# Exhibit 2

## Re: Zoning Questions - 3021 15TH ST NE

The following pertains to a proposed accessory apartment being built at 3021 15<sup>th</sup> Street NE, Washington, D.C. 20017. For at least the reasons summarized below, the owners of 1507 Irving Street respectfully contest the placement of the permitted construction as nonconforming with the plain meaning of the Zoning Regulations of 2016.

The 3021 15<sup>th</sup> Street NE, Washington, D.C. 20017 (Lot 22 of Square 4017) (“3021 15<sup>th</sup> Street”) property owners obtained a Permit (No. B2309496) (“Permit”) on August 23, 2024. The permit’s description of work explains that the “exist[ing] clay block & brick garage & accessory structure” (“Existing Structure”) will be repaired.<sup>4</sup>

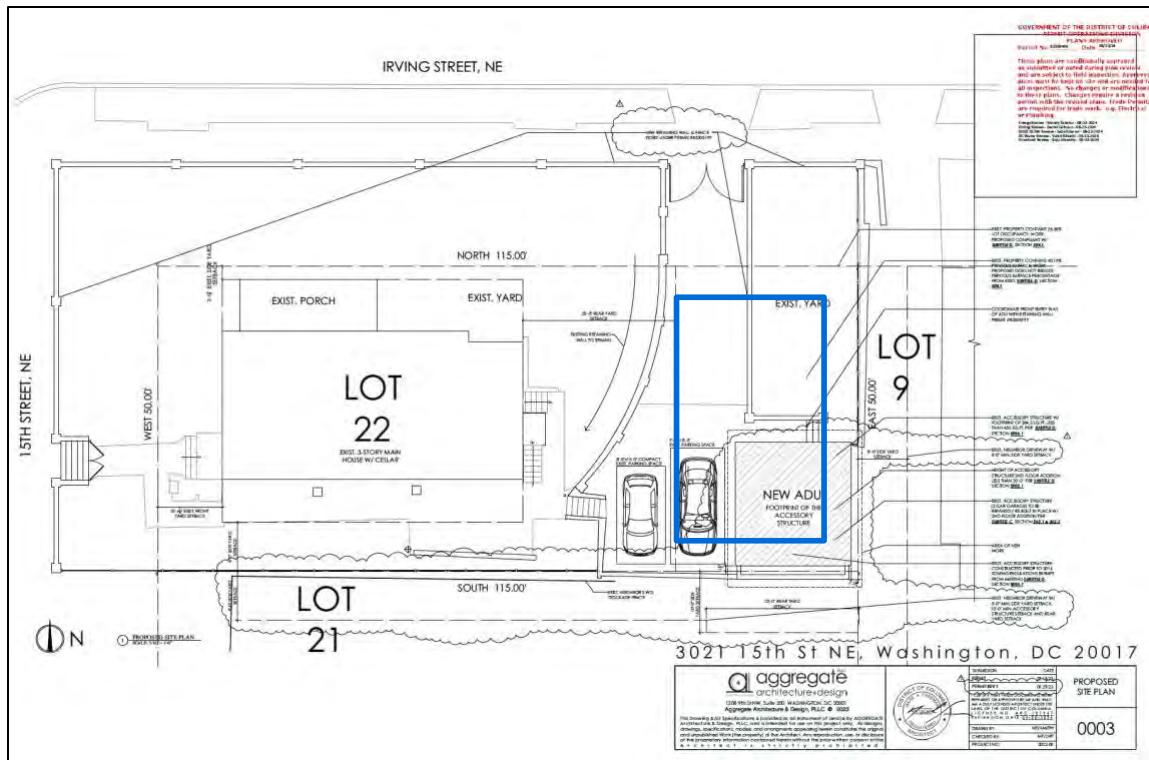
The location of the proposed accessory apartment does **not** comply with the Regulations.

As required by both Subtitle D, Chapter 2, and Subtitle D, Chapter 50, the proposed construction cannot be placed in either side yard of the principal building on Lot 22 due to the placement and size of the principal building on the lot. *See* Subtitle D, § 208.2 (requiring all detached buildings have a side yard of at least eight feet in the R-1 zone) and Subtitle D, § 5005.1 (imposing an additional requirement that, in addition to leaving a minimum of eight feet of side yard between the accessory apartment and the lot line, that the accessory apartment must leave a minimum of ten feet between the principal dwelling and accessory building). Likewise, an accessory building cannot be located within the required rear yard of the principal building. Subtitle D, § 207.1 (requiring 25 foot minimum rear yard depth); Subtitle D, § 5005.1 (confirming that the required 25 foot minimum rear yard is not enlarged).

For at least these reasons, the Irving Street Homeowners respectfully request that the proposed accessory apartment be set back 8 feet from their property line—as required under the plain meaning of the Regulations, as well as to preserve the safety and value of their home.

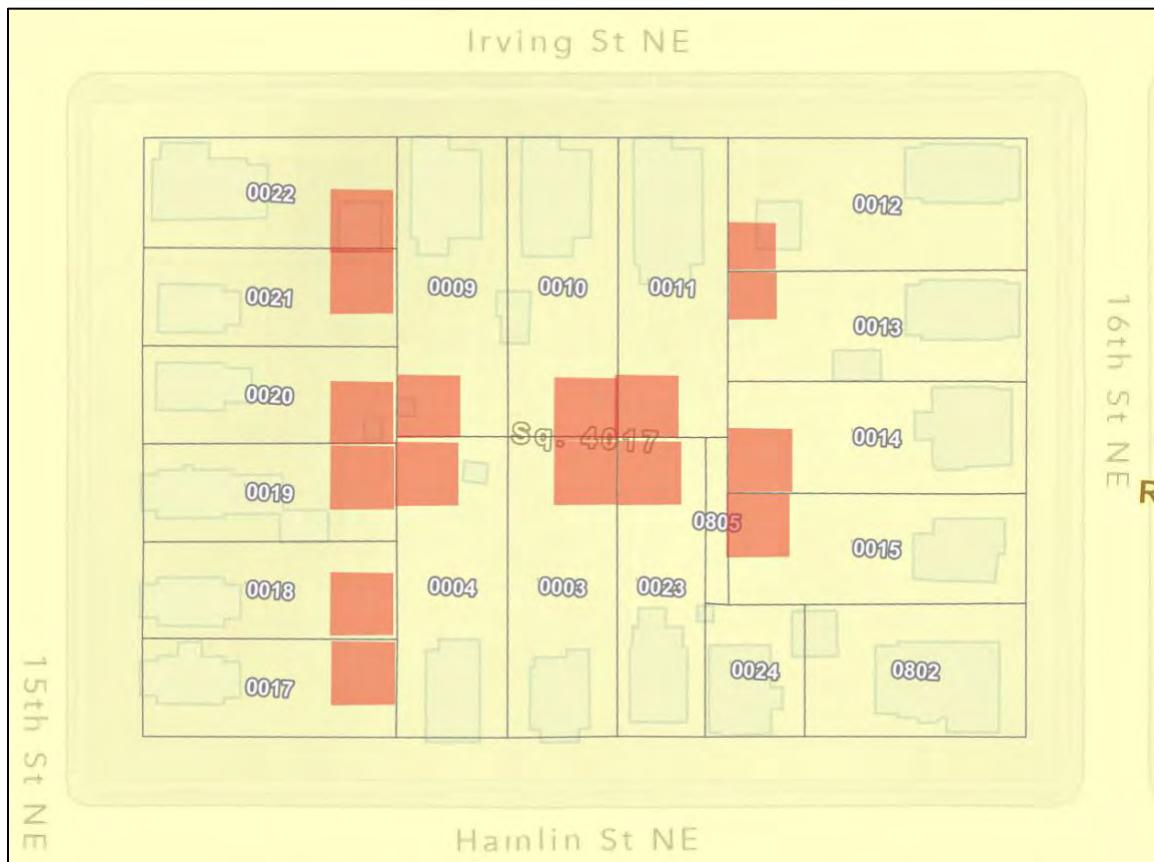
Finally, because the proposed construction involves an accessory apartment in the R-1 zone, the proposed construction must comply with Subtitle U, Chapter 2, requiring, *inter alia*, accessory apartments that are constructed as detached accessory buildings “**be located such that it is not likely to become objectionable to neighboring properties** because of noise, traffic,

parking, or *other objectionable conditions*,” Subtitle U, § 253.8(f)(1), and *without exception* via modification or waiver, accessory apartments situated in accessory buildings “*shall not conflict with the intent of this section to maintain a single household residential appearance* and the character of the R zones,” Subtitle U, § 253.10(c). These sections of Subtitle U, Chapter 2 require the Department of Zoning consider not just the restrictions on the individual lot where the accessory apartment will be located—but also the neighboring properties.<sup>7</sup>
